**JOINT REGIONAL PLANNING PANEL**  
**Sydney East Region**

<b>JRPP No:</b>	2011SYE128
<b>DA No:</b>	DA2010/1839
<b>Modification No:</b>	MOD2011/0246
<b>Local Government Area</b>	Warringah Council
<b>Proposed Development</b>	Section 96(2) Modification of DA2010/1839 for demolition works and construction of residential flat buildings and associated basement car park including landscape/site works
<b>Address / Property Description:</b>	Lot 1 in DP 1136022, No. 2 Mooramba Road, Dee Why; and Lot 2 in DP 1136022, No. 10 Painters Parade, Dee Why
<b>Applicant:</b>	Dee Why Property Development Pty Ltd
<b>Number of Submissions</b>	Nil
<b>Recommendation</b>	Section 96(2) Approval
<b>Report by:</b>	Peter Robinson, Acting Deputy General Manager for Warringah Council

### Assessment Report and Recommendation

Modified by the author from Plan No. DA05 – Site Analysis 2 by JAA Studio

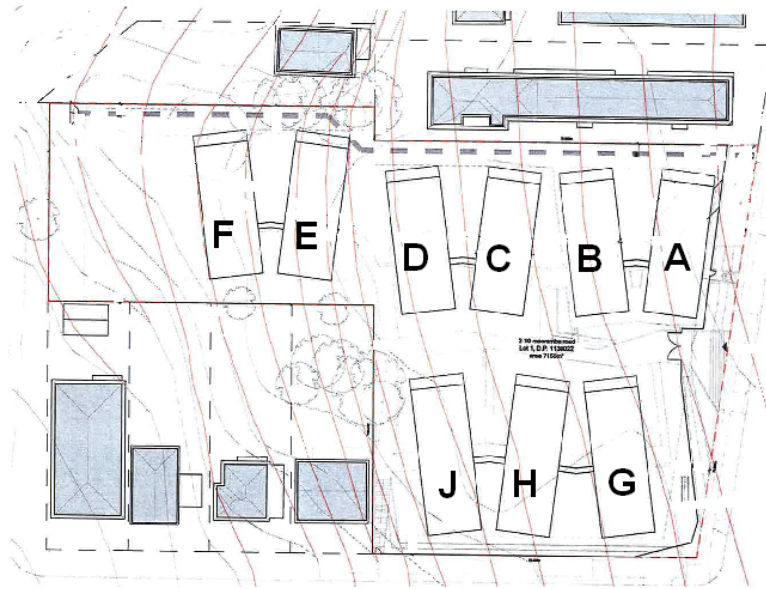
- The floor level of the eastern two-thirds of the basement car park is lowered by 150mm (from RL 27.71 to RL 27.56);
- The floor level of the western one-third of the basement car park is raised by 190mm (from RL 27.71 to RL 27.90);
- Plant Room/Interim Garbage Store located to the south of the driveway is redesigned to provide a plant room with direct street access to Mooramba Road;
- An electrical switchroom is incorporated adjacent to the Central Waste Holding Bay;
- Deletion of staircase in south-east corner;
- Washroom facilities are added in the southern side of the car park for maintenance personnel; and
- The internal layout of the car park has been partially redesigned to accommodate the above-mentioned changes. The car park maintains the approved 151 car parking spaces.

- A substation is added to the front setback area facing Mooramba Road and immediately south of the approved driveway;
- A hydrant booster is added to the front setback area facing Mooramba Road;
- A 0.5m high mechanical exhaust turret which services the basement car park is incorporated into the landscaped area facing Mooramba Road;
- Three air intake vents which service the basement car park are included along the northern side of the property abutting the approved stormwater easement;
- An access footpath is proposed over Council owned land from the southern side of the property to the street alignment of May Road;
- The raised landscaped areas between the buildings include boulder/wall edging around the base of each mound to improve stability and restrict organic matter from interference with drainage;
- Inclusion of eight (8) external hydrants throughout the property;
